Project: 10-20-25 QT #0847 GAINESVILLE, GA

Project: 10-20-25 QT #0847 GAINESVILLE, GA
Function: Test, Adjust, & Balance

Issue List

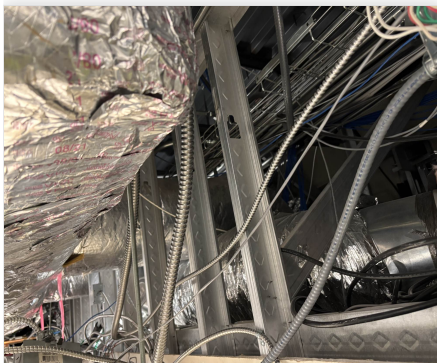
Issue Name : RTU-3: Kitchen Diffusers Incorrect Style
Description : Kitchen diffusers 3-1, 3-2, 3-3, and 3-4 are substitutes until the correct Titus Diffusers can be installed.
Created By : National TAB **Assigned To :** National TAB - Dan Hertenstein
Status : Open
Priority : High **Asset Tag :**
Originated Date : 10/23/2025 - Sagar Patel - National TAB

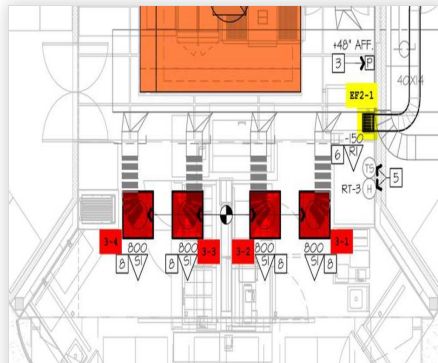
Issue Name : RTU-3: Kitchen Supply Diffuser Ductwork Incorrect
Description : RTU-3 Diffusers 3-1 and 3-4 in the kitchen are not connected to the supply duct. They are still connected to the return duct. This will need to be corrected. RTU 3 is balanced to total design airflow.
Created By : National TAB **Assigned To :** National TAB - Dan Hertenstein
Status : Open
Priority : Urgent **Asset Tag :**
Originated Date : 10/23/2025 - Sagar Patel - National TAB
